ADDENDUM

No. 02 Date: 9/5/2024
Project No. 0020711.01 Attention: Leonard D'Souza
Project Name: Princess Margaret Cancer Centre
Stem Cell Transplant 2, MHC, MHDU, DSC
Address: University Health Network
610 University Avenue
Toronto ON

Project Name:	UHN PM Stem Cell Transplant Phase II Part A	Date Issued:	September 5, 2024
Quasar Project #:	HC-21-058		
Distribution			
Cannon Design Ltd.	Linda Vela	lvela@cannondesign.com	
Cannon Design Ltd.	Jennifer Huynh	jhuynh@cannondesign.com	
Quasar Consulting Group	Alexandra Blagojevic	alexandra.blagojevic@quasarcg.com	
Quasar Consulting Group	Jerry Guidarelli	jerry.guidarelli@quasarcg.com	
Quasar Consulting Group	Jomuel Estranero	jomuel.estraneo@quasarcg.com	
Quasar Consulting Group	Manda Bobinac	manda.bobinac@quasarcg.com	
Addendum #:	M-1		
Revision #:	0

Project Name:	UHN PM Stem Cell Transplant Phase II Part B	Date Issued:	September 5, 2024
Quasar Project #:	HC-21-058		
Distribution			
Cannon Design Ltd.	Linda Vela	lvela@cannondesign.com	
Cannon Design Ltd.	Jennifer Huynh	jhuynh@cannondesign.com	
Quasar Consulting Group	Alexandra Blagojevic	alexandra.blagojevic@quasarcg.com	
Quasar Consulting Group	Jerry Guidarelli	jerry.guidarelli@quasarcg

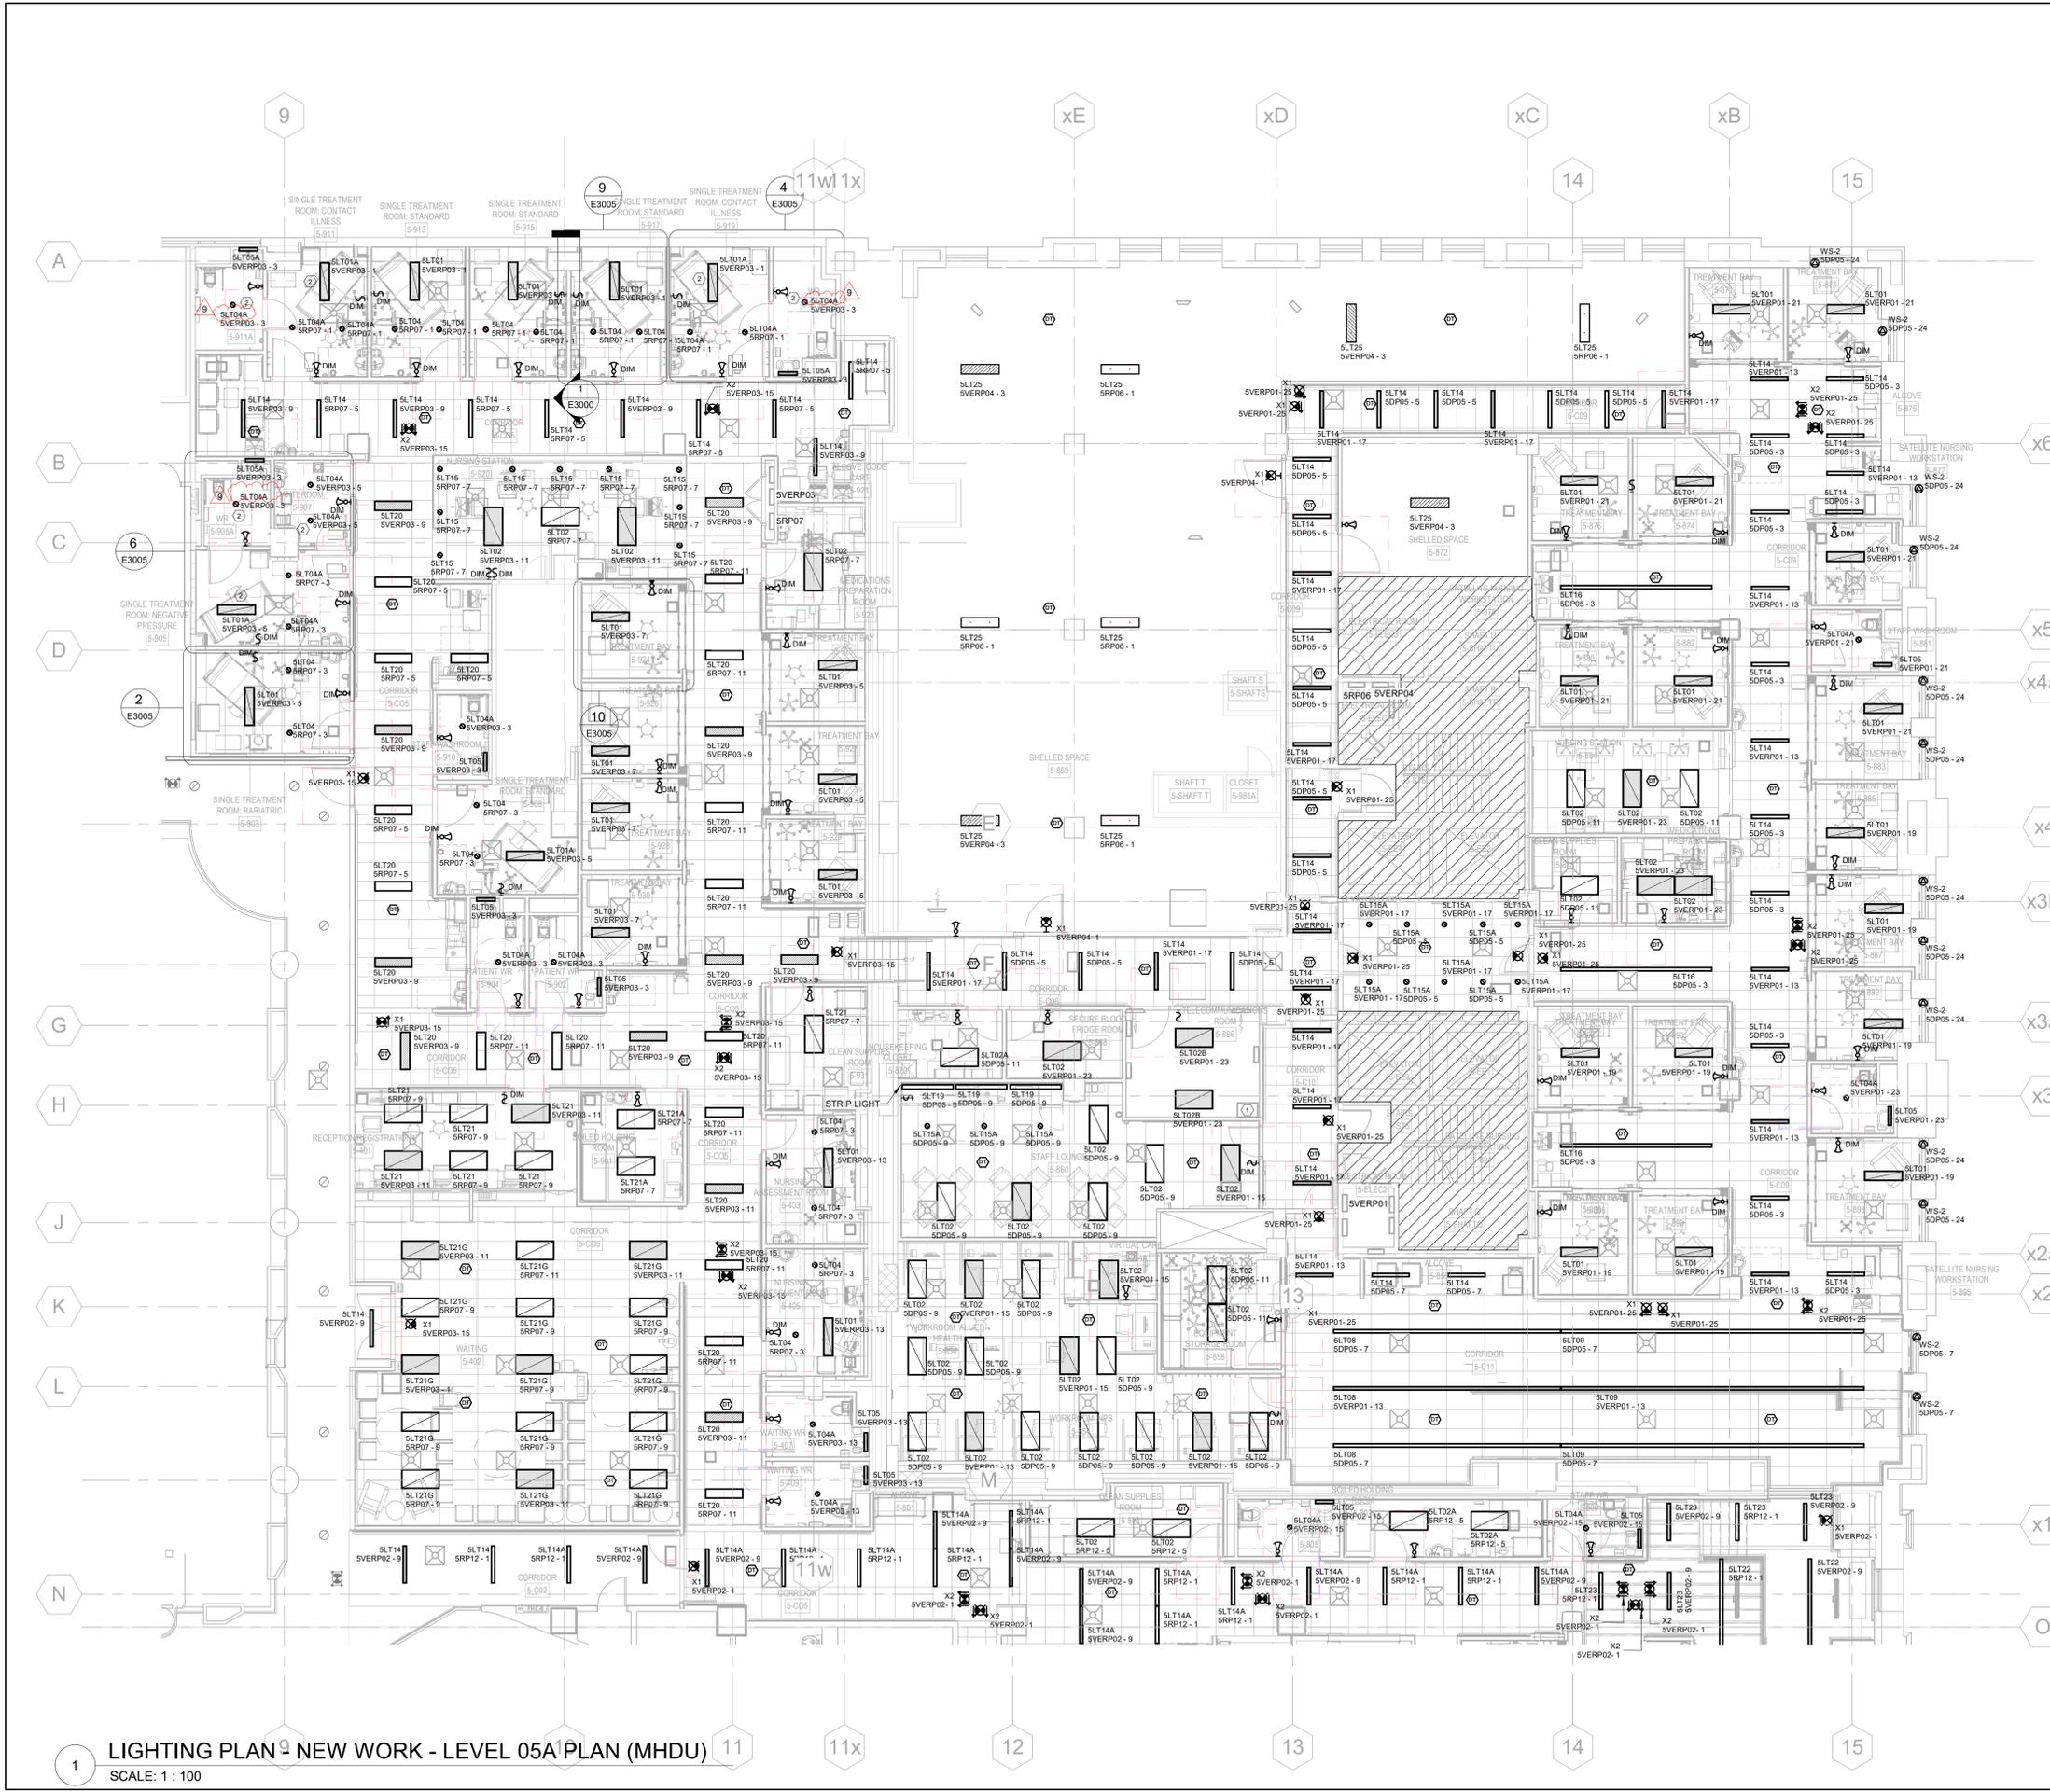
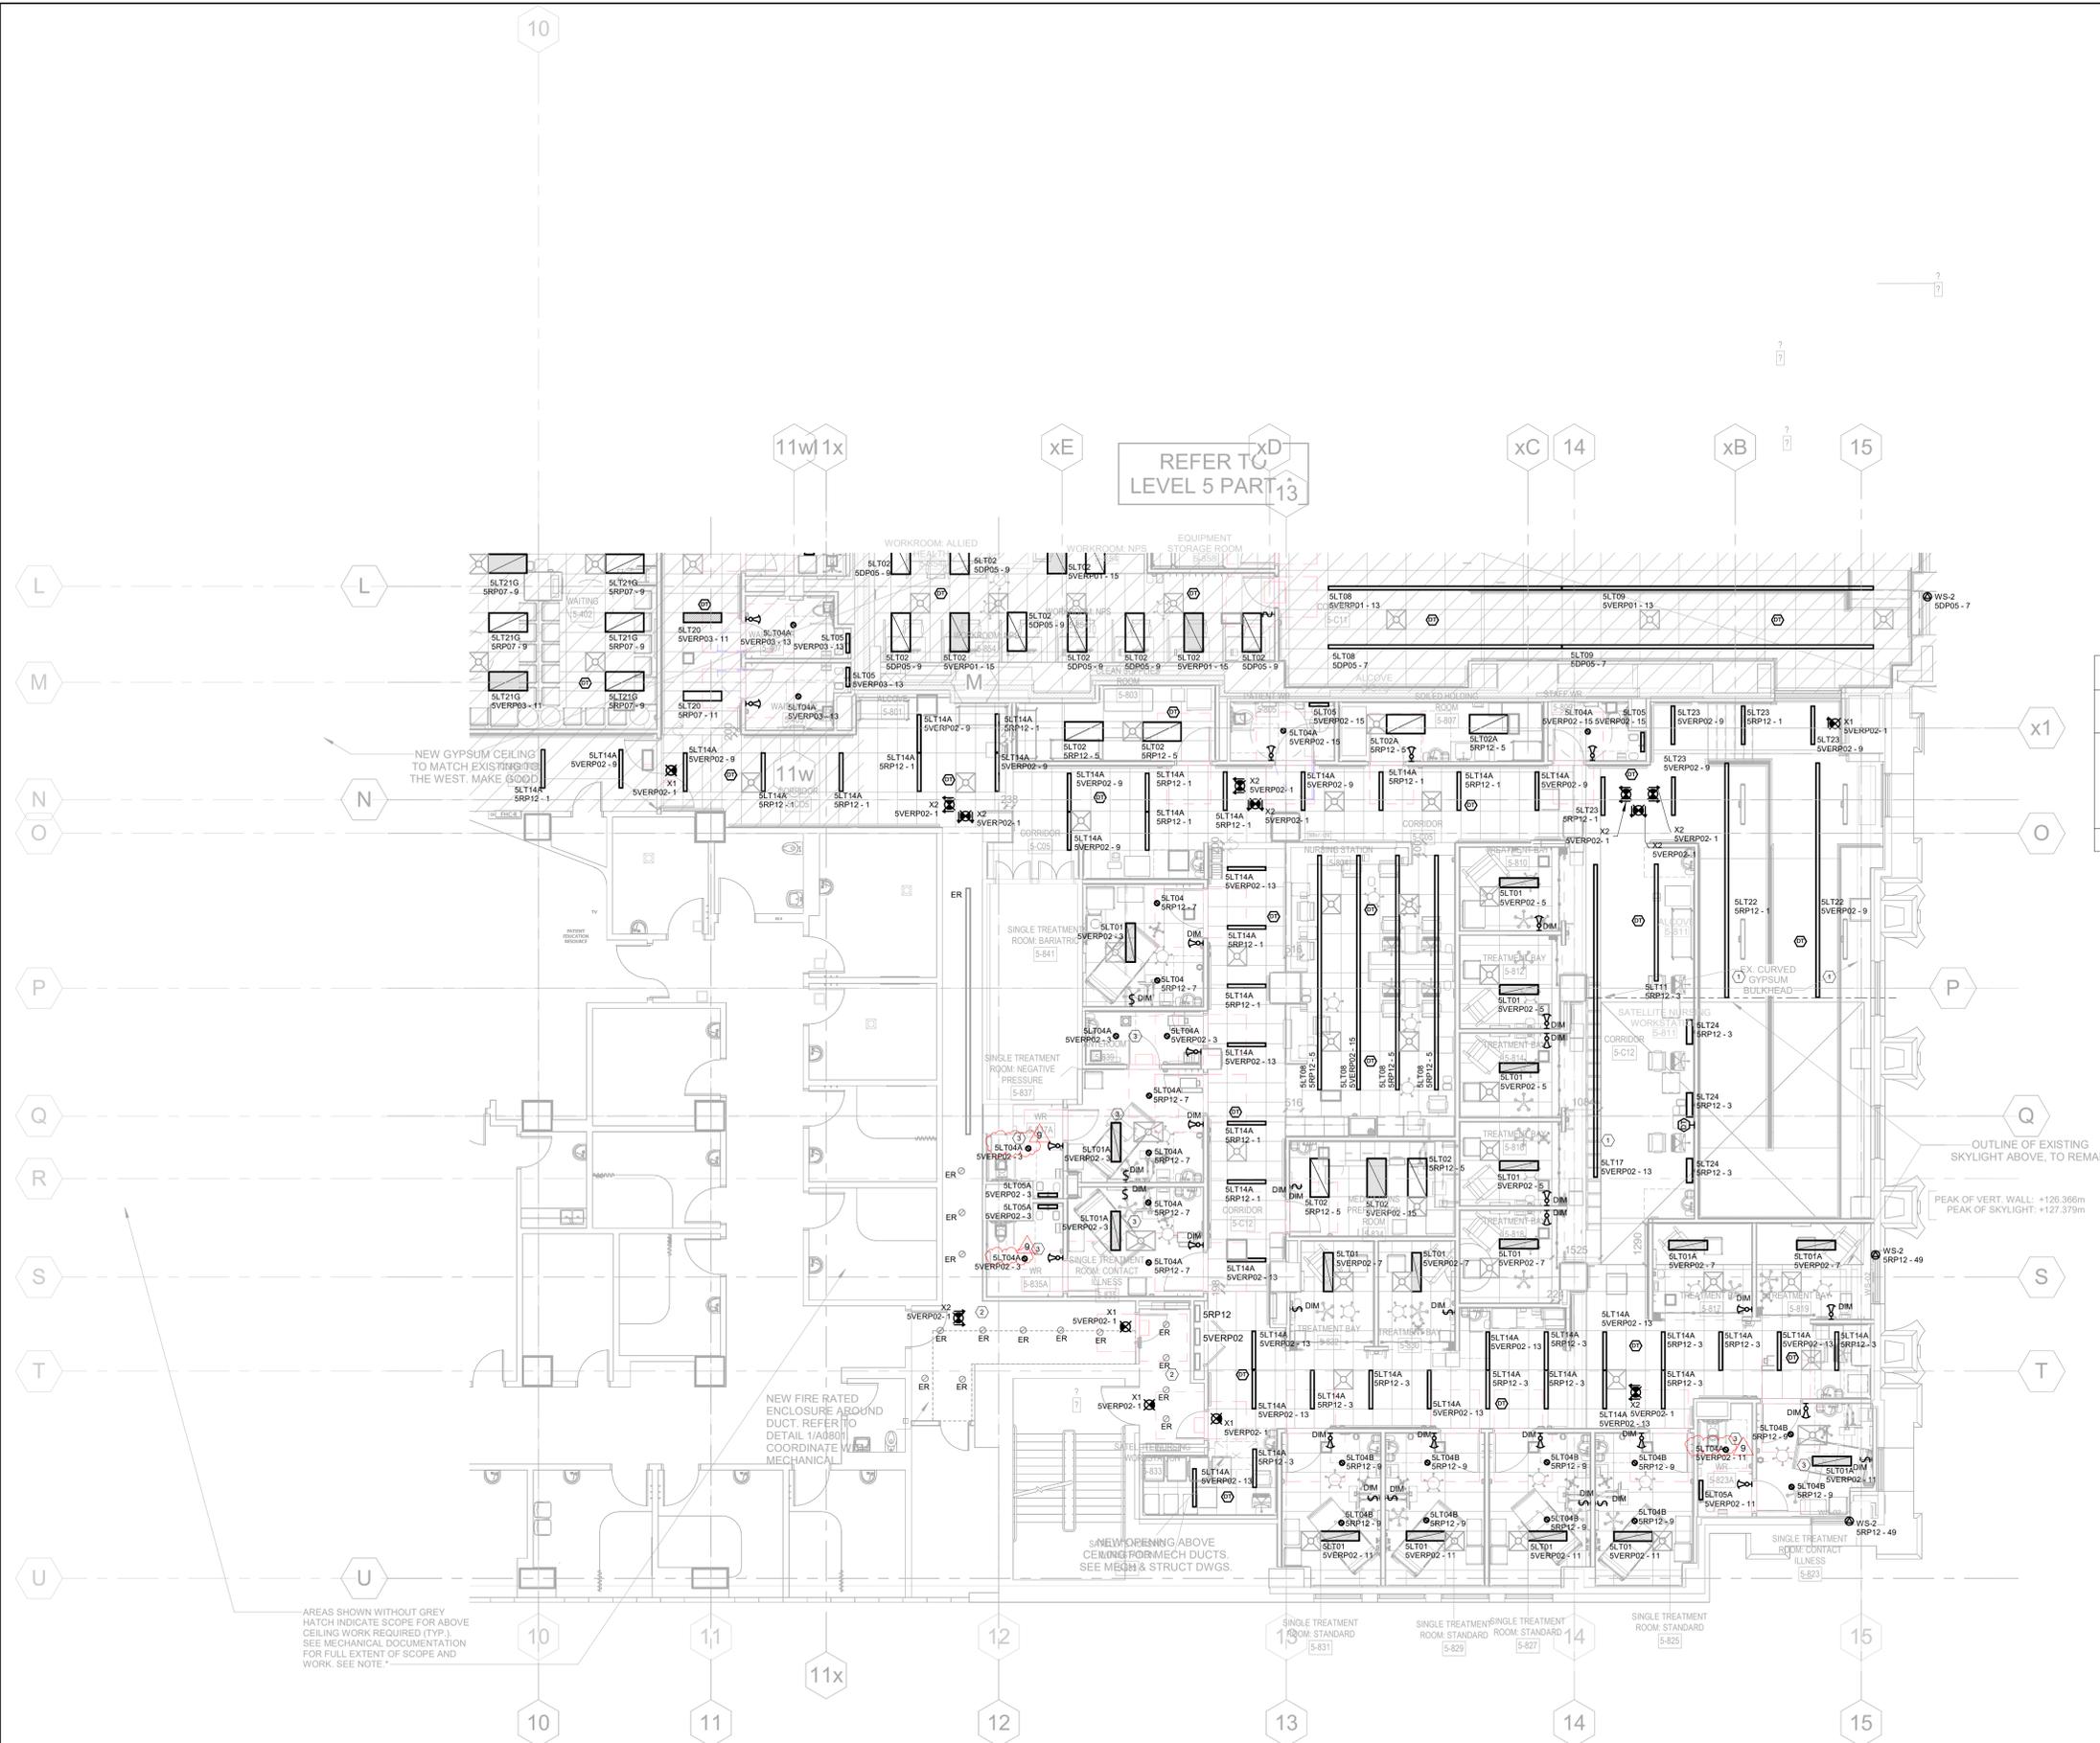
QCG E: (81) The Drawings have been reviewed and luminaires should be 5LT04A INSTEAD 5LT06 AND 5LT06A FOR NEGATIVE PRESSURE WASHROOMS, the drawing has been refer to addendum E-1 for updated E2205A AND E2205B

- Modification Clouded in Compliance with RFI question (81)
6. **Drawing E-2205B– LIGHTING - NEW WORK LVL 5B – MHDU**
- Modification Clouded in Compliance with RFI question (81)
